UNITED STATES PATENT AND TRADEMARK OFFICE

APPLICATION NO.	FILING DATE	FIRST NAMED INVENTOR	ATTORNEY DOCKET NO.	CONFIRMATION NO.
10/729,679	12/05/2003	Kenneth M. Sprouse	7784-000644	3173

Office Action Summary

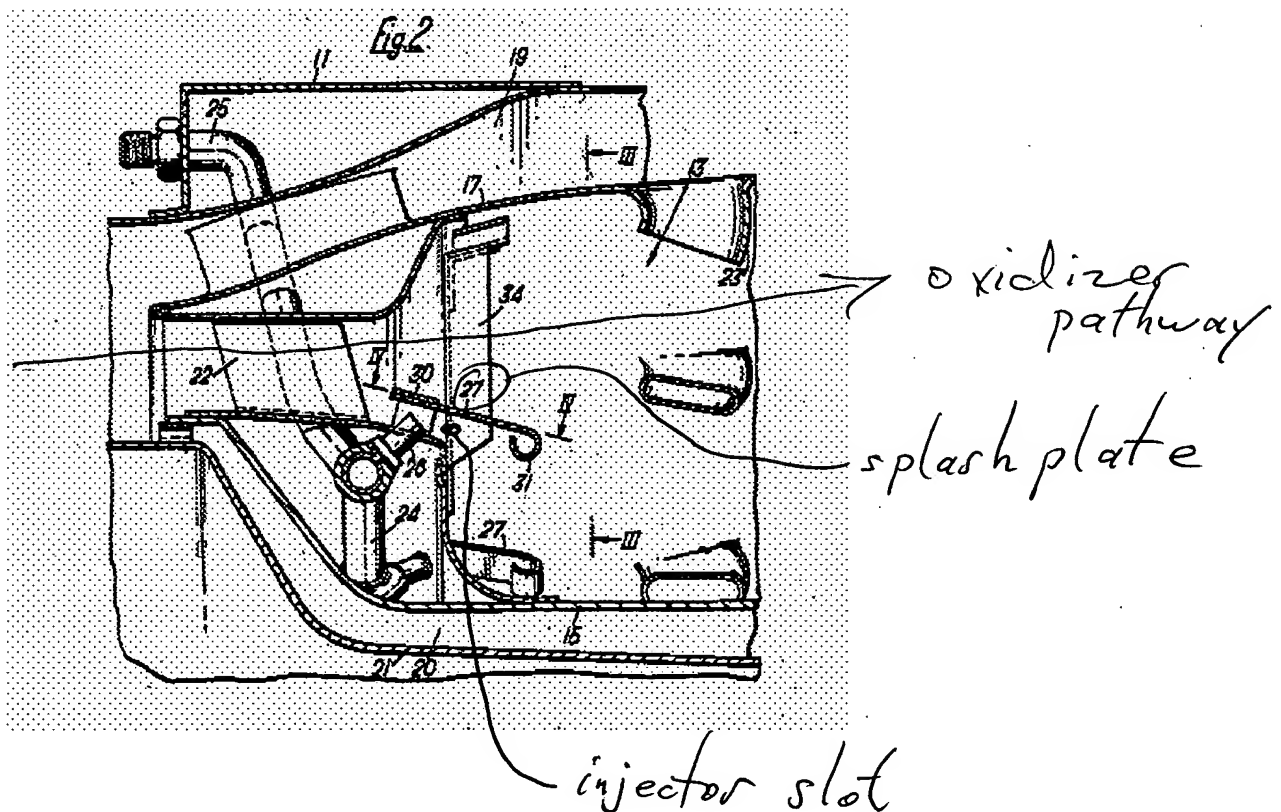
Claims 12, 13, 15, 16, 17, 22, 23, 24 and 25 are rejected under 35 U.S.C. 103(a) as being unpatentable over Carlisle in view of Amann. Carlisle discloses the invention substantially as claimed. However, Carlisle does not disclose a preheat section to heat the oxidizer. Amann discloses that it is known to use a regenerator 7 to preheat the oxidizer in order to recover energy which would otherwise be wasted. In view of this teaching, it would have been obvious to provide the gas turbine of Carlisle with a recuperator for heating the oxidizer. Figure 2 of Carlisle is reproduced below with the relevant portions labeled with the corresponding claim elements. Regarding claims 23 to 25, these claims merely recite the intended use of the injector

FIG. 1

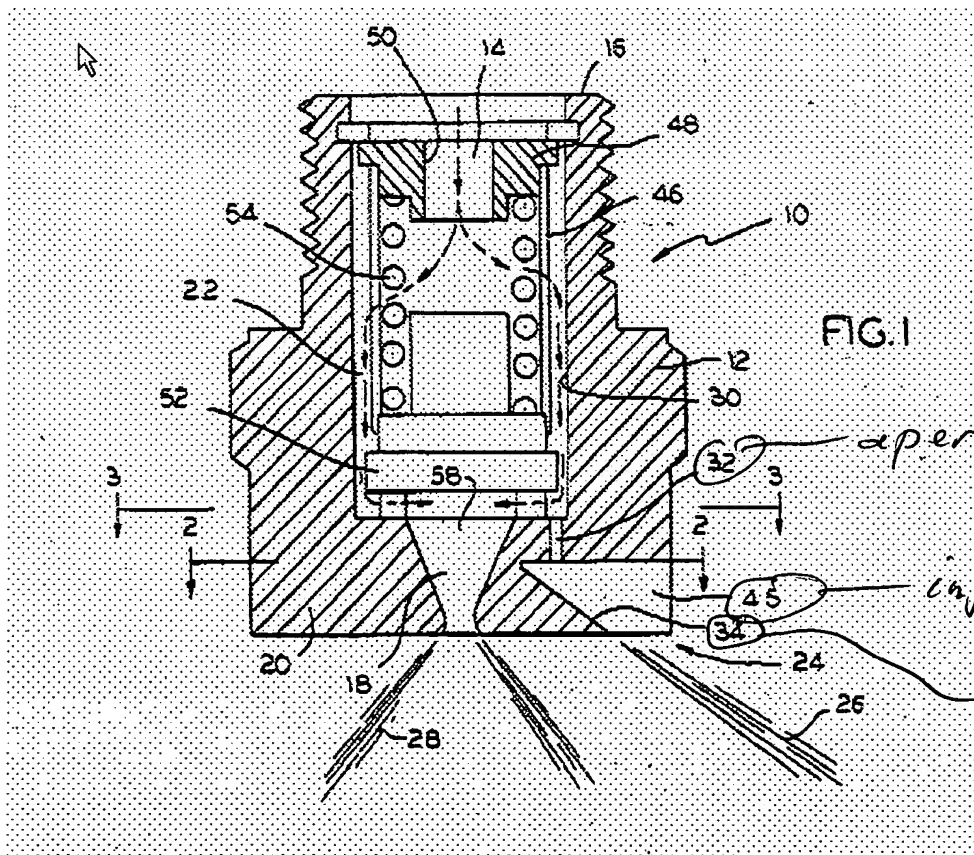
heat the oxidizer. Amann discloses that it is known to use a regenerator 7 to preheat the oxidizer in order to recover energy which would otherwise be wasted. In view of this teaching, it would have been obvious to provide the gas turbine of Shekelton et al. with a recuperator for heating the oxidizer. Figure 1 of Shekelton et al. is reproduced below with the relevant portions labeled with the corresponding claim elements. Regarding claims 23 to 25, these claims merely recite the intended use of the injector and do not define structurally over the injector of Shekelton et al. The injector of Shekelton et al. is inherently capable of injecting different fuels.

aperture

injector slot

"splash plate"
